PME UTILITY PLAN & PHOTOMETRICS
SCALE: 1" = 20'-0"

FREEDOM SPRINGS
734 WESTERN DRIVE
COLORADO SPRINGS, EL PASO COUNTY,
COLORADO, 80915

PME UTILITY PLAN
PME-100

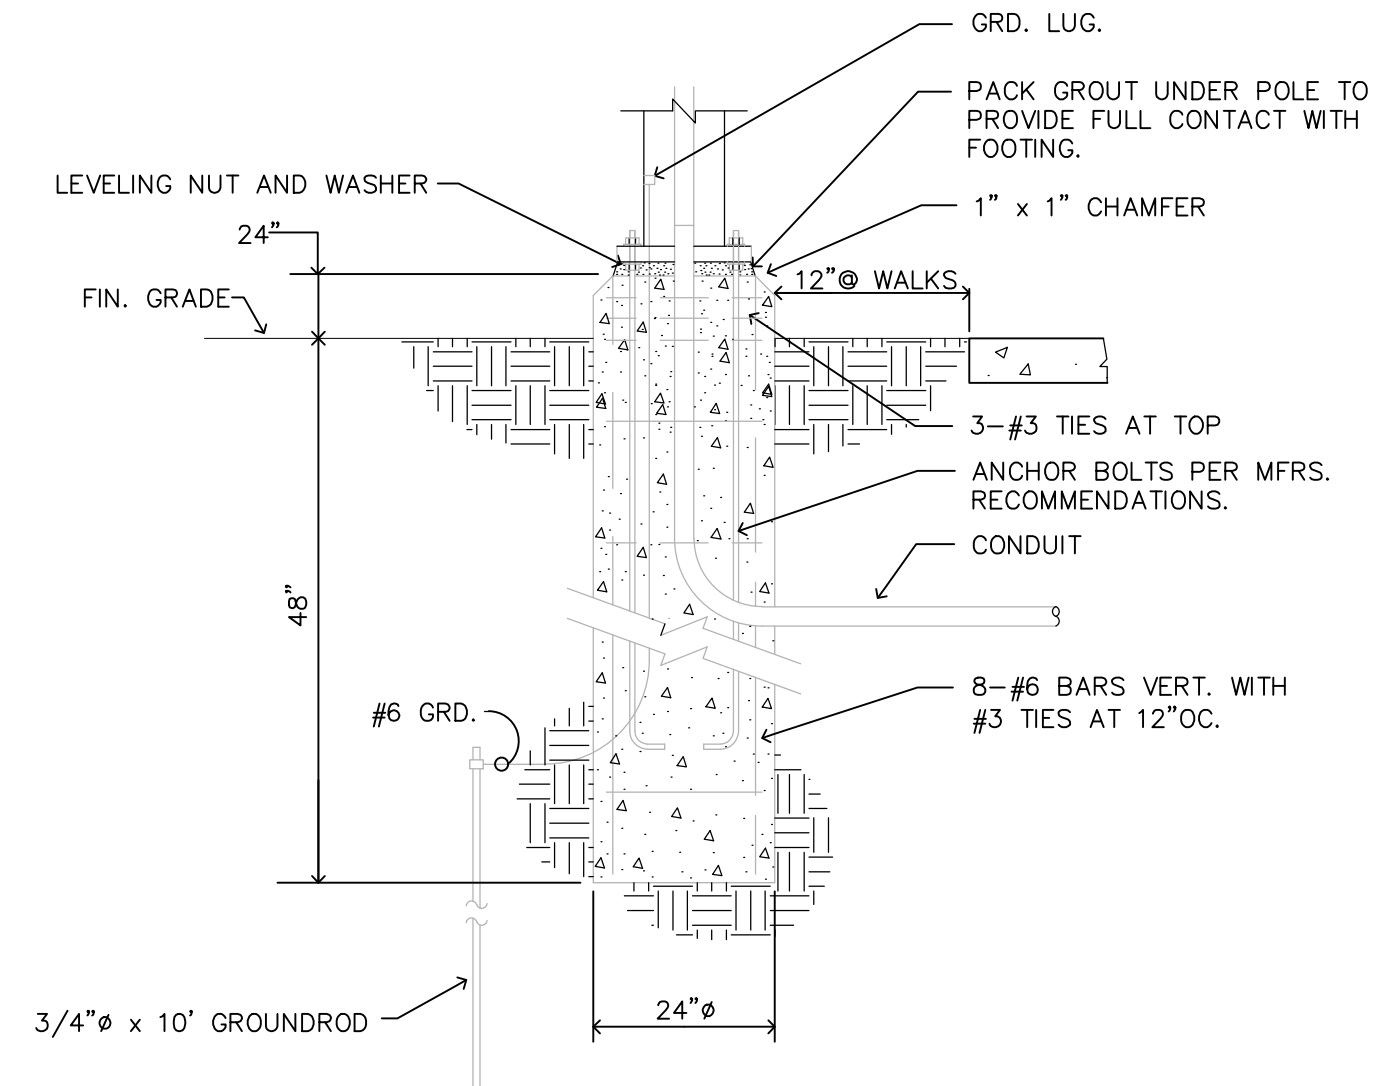
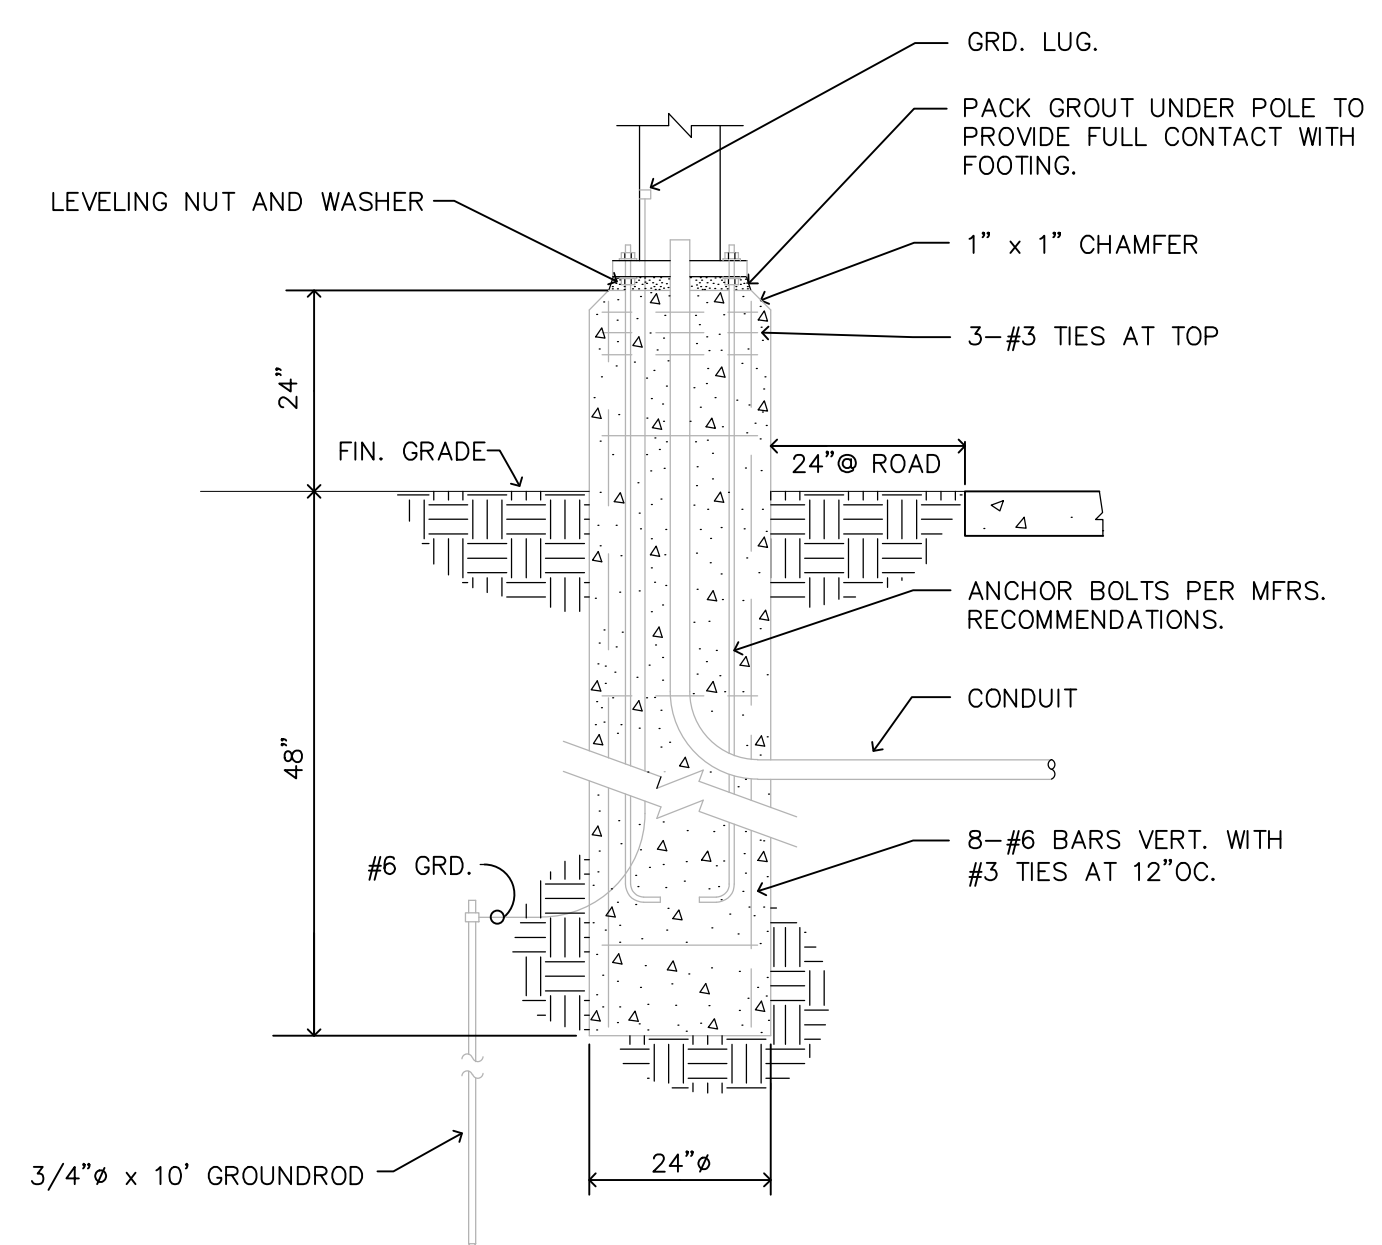
Detail sheet of light pole height to verify it meets standards in the LDC

Needs to be a full photometric to determine scale at boundary line.
